From: Zagorski, Joseph <Joseph.Zagorski@ottawa.ca>
Sent: Wednesday, May 21, 2014 5:14 PM
To: Cara Ruddle; Lee Sheets
Cc: Diduch, Roman; John Riddell; Tse, Wendy; Ogilvie, Chris; Whittaker, Damien
Subject: FW: Kanata North - sanitary memo 2

Please see my comments regarding your April 9 2014 Sanitary Servicing memorandum for the Kanata North Urban Expansion Area:

KANATA NORTH URBAN EXPANSION AREA **COMMUNITY DESIGN PLAN**

KANATA NORTH URBAN EXPANSION POTABLE WATER ASSESSMENT

Figure 1-3: Existing Zone 2Ww Pipe Network (diameter shown in mm)

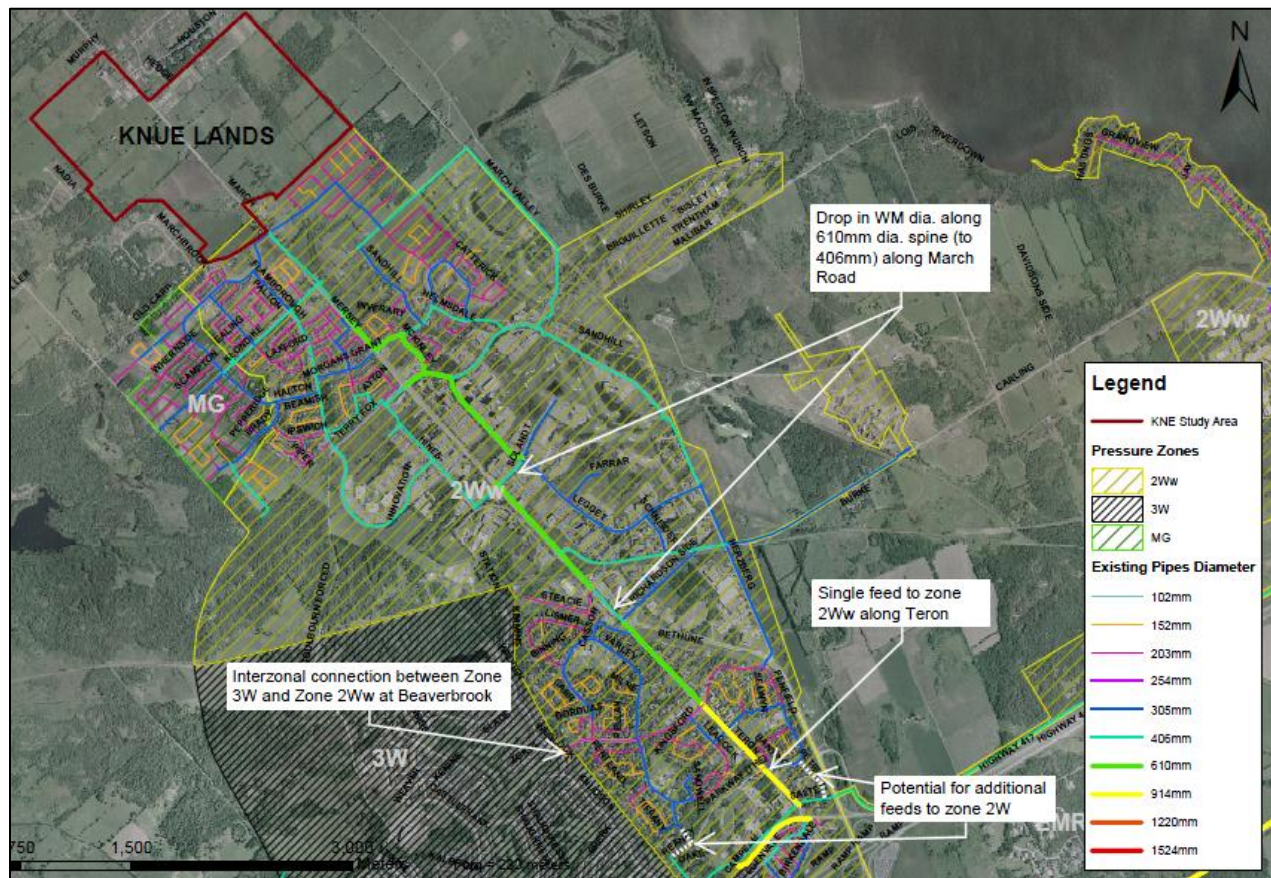
1. Figure 1-3 should identify the private watermains referred to in the text on p.1.3. An image illustrating private mains in the area of interest is attached (private mains buffered lime green).

Figure 3-1: KNUE Lands Model Node ID's

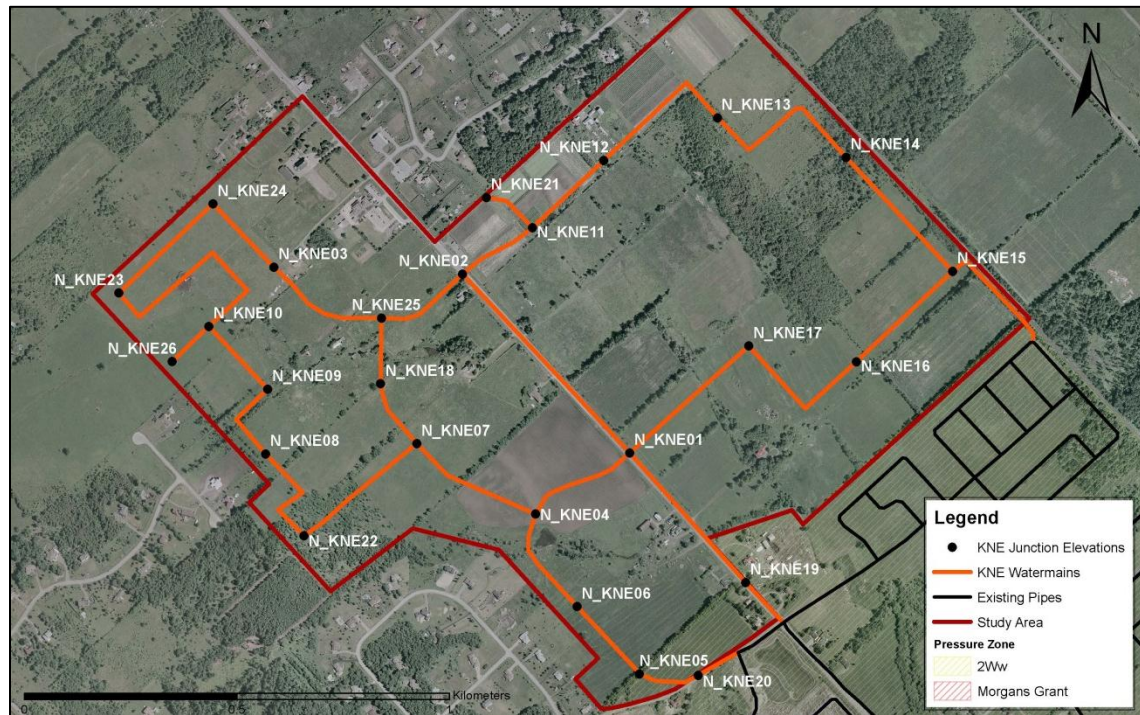
1. Section 1.2 – review this section – suspected error in cardinal direction reference
2. Figures 3-1 and 3-2 are unclear – node and pipe ID's are illegible
3. In figure 3-3, node allocation unclear for a few demand areas. Demand area ID's are illegible.
4. Figure 3-4 title is confusing. Please confirm that the curves represent existing (2012) demands plus future build-out of the KNUE area.
5. Clarify if results presented in Figure 3-12 are with or without March/Solandt upgrades.

Figure 3-8: Minimum Pressures (psi) with Upgraded 2Ww Network & Existing + KNUE PKHR Demands

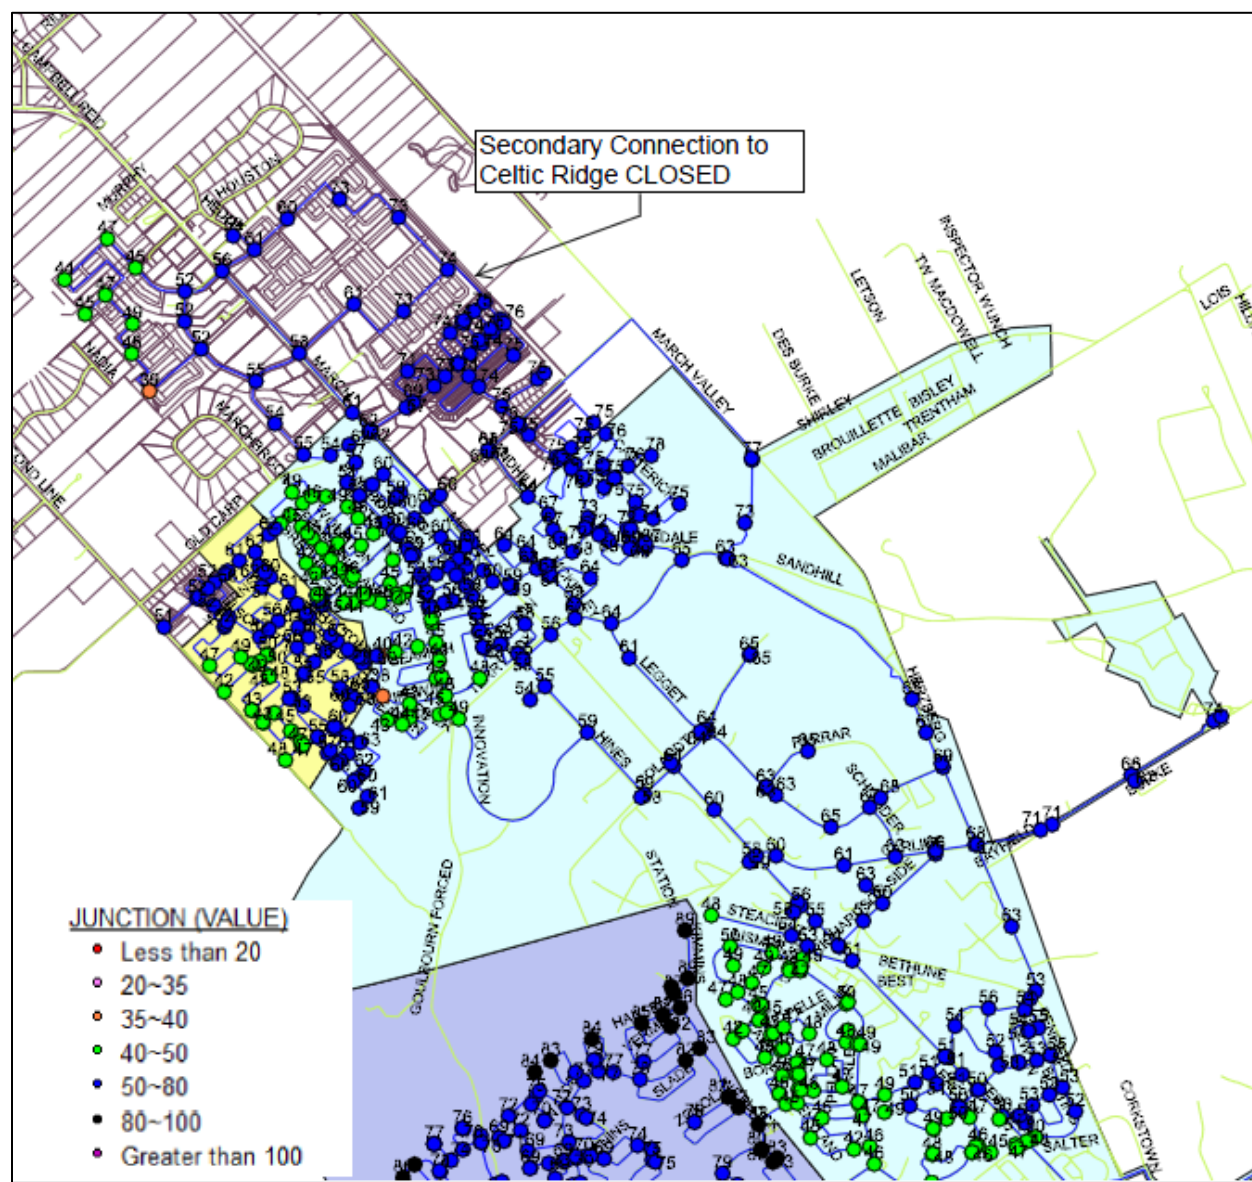
- Please verify that Figure 3-8 is correct. It appears to be the same plot as Figure 3-6.
- What is the change in minimum pressure in the existing Zone 2Ww with the proposed upgrades to the existing 2Ww backbone?

Figure 3-10: KNUE Pressures under Existing 2Ww Pipe Network & Existing + KNUE 2012 BSDY Demands with a pipe failure along the KNUE March Road feed.

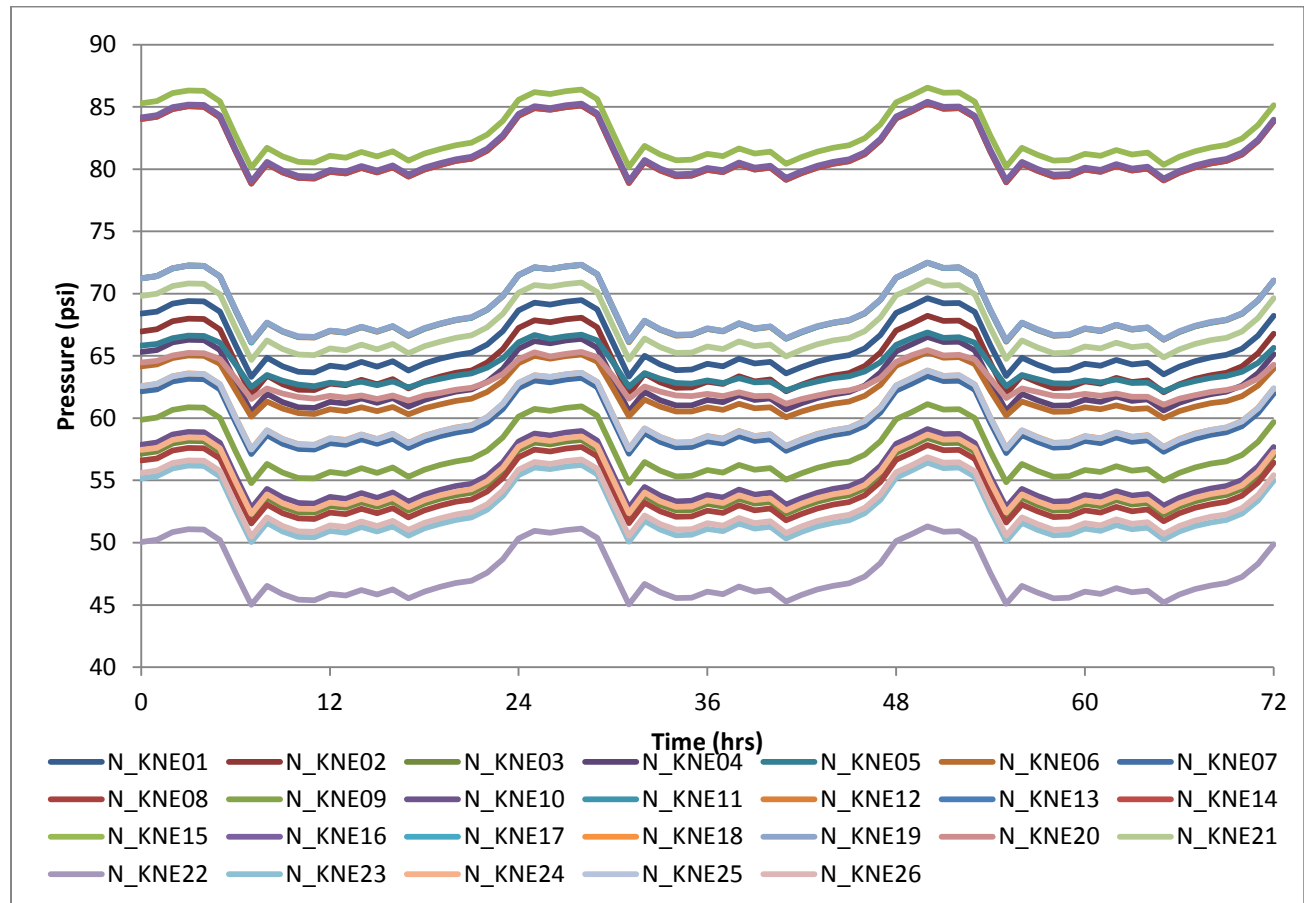
- Results for a failure of the 406mm feed into KNUE for winter demand and no fire should be presented, to confirm that minimum pressures would remain above 40 psi under this condition.
